Airworthiness Directive

AD No.: 2014-0118R1

212, 412 and 412EP helicopters

ATA 63 – Main Rotor Drive – Engine-to-Transmission Drive Shaft Line Nuts – Inspection / Replacement

Fig. 1

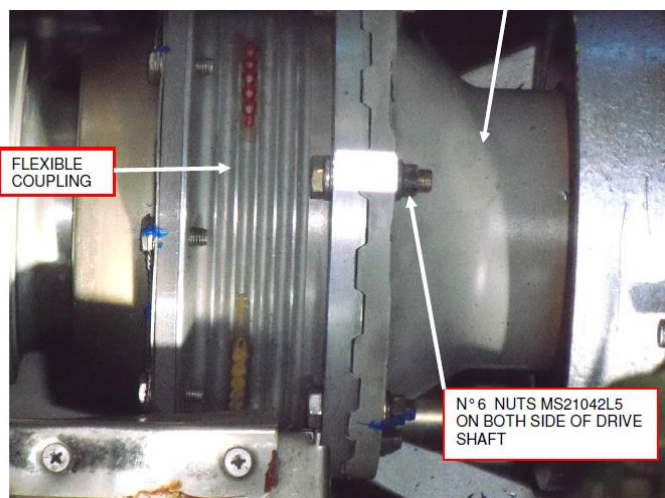
- 1) Prepare helicopter for safe ground maintenance; disconnect battery and all the electric power source and/or the external power supply.
- 2) In accordance with the applicable Maintenance Manual Chapter 63, gain access to the engine-to- transmission drive shaft.
- 3) Using a source light and a mirror, inspect the nuts P/N MS21042L5 connecting the flexible coupling with the adapter installed on the engine-to-transmission drive shaft (refer to Fig. 1) or inspect the nuts P/N MS21042L4 connecting the flexible coupling with the adapter and nuts P/N MS21042L4 connecting the drive shaft with the flexible coupling (refer to Fig. 2). The configuration depends on the helicopter model and s/n.

Fig. 3

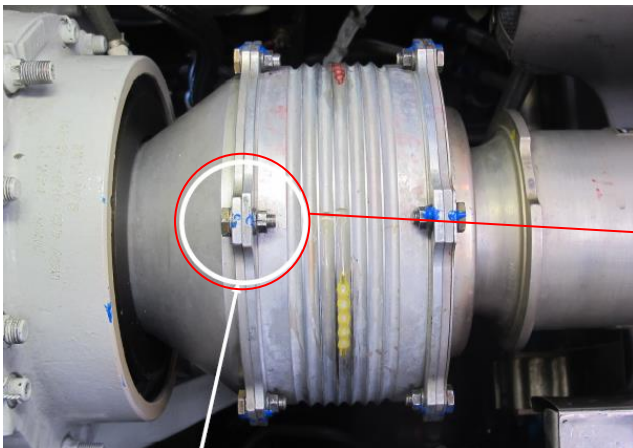
Note 1: For a typical crack, refer to Appendix 1 of this AD, Fig. 3 and Fig. 4.

- (2) If, during any inspection as required by paragraph (1) of this AD, a nut is found cracked (see Note 1 of this AD), before next flight, replace the nut with a serviceable part having a different P/N in accordance with the instructions of Appendix 2 of this AD.
